New processor card SA 1

New Processor Card SA 1		Förster Technik GmbH		Zeichnungs-Nr. ski49c		Blatt			
						gezeichnet		Datum 13.05.93		Auftrags-Nr.			
Änderung				Ind.		Datum		Name		von		Blätter	
						Name		Ruh		Kom.-Nr.

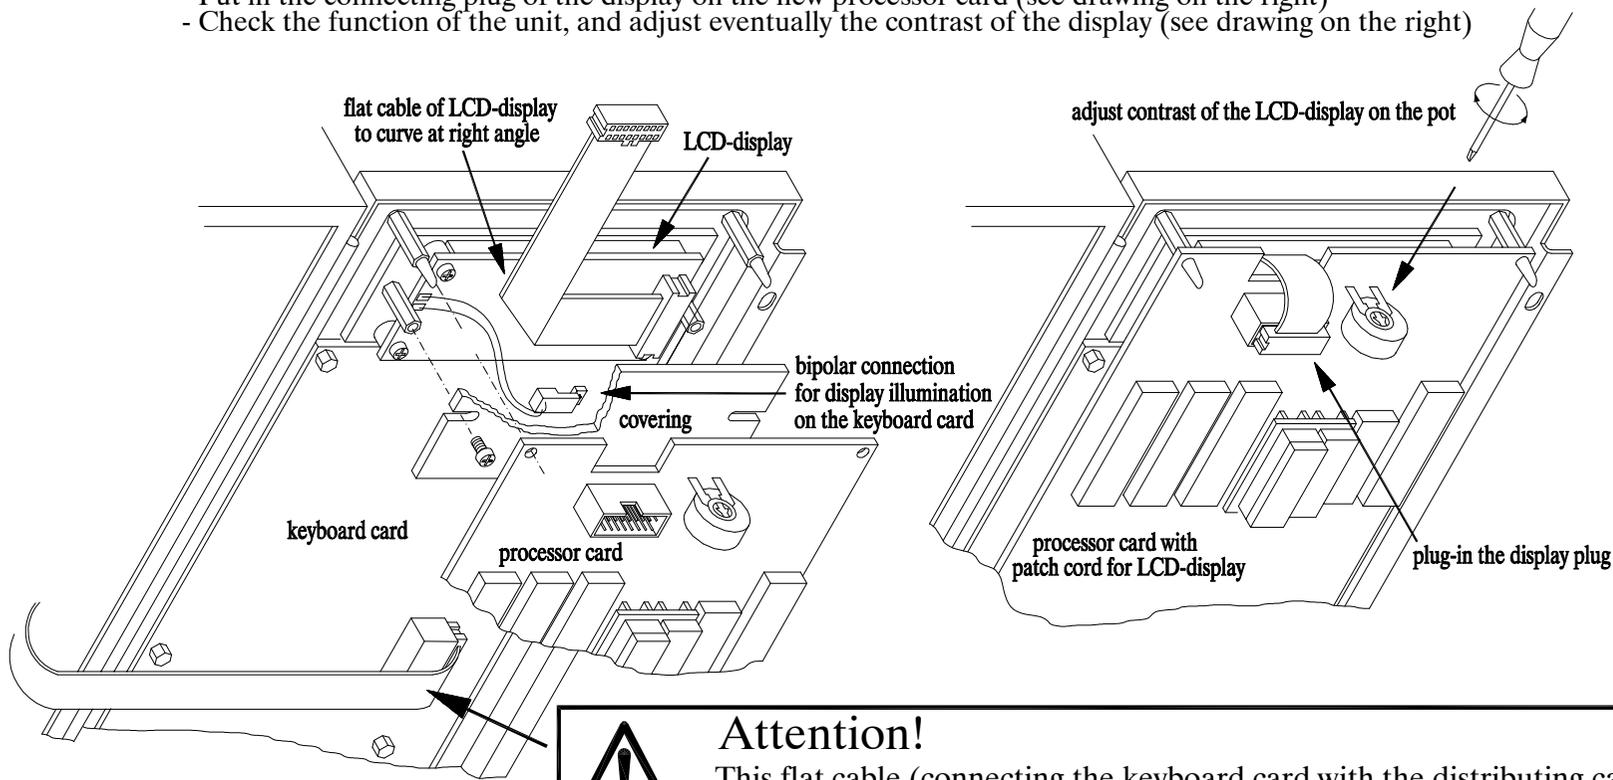
Since April 1993 the Stand Alone units have been equipped with new processor cards which can easily be subject to interference. The new processor cards are fully compatible with the previous processor cards, however, the connection of the LCD-display has to be modified. Now the display must be connected directly to the processor card and not to the keyboard card as before. The small bipolar plug for the display illumination is still connected to the keyboard card.

Attention!
 This flat cable (connecting the keyboard card with the distributing card) must not be put into the processor card, otherwise this would be destroyed!

- Proceeding:
- Detach the previous processor card as well as the covering above the display.
 - Take off the connecting plug of the display from the keyboard card and curve the flat cable at right angles (see drawing on the left).
 - Put on the covering above the display and insert the new card.
 - Put in the connecting plug of the display on the new processor card (see drawing on the right)
 - Check the function of the unit, and adjust eventually the contrast of the display (see drawing on the right)
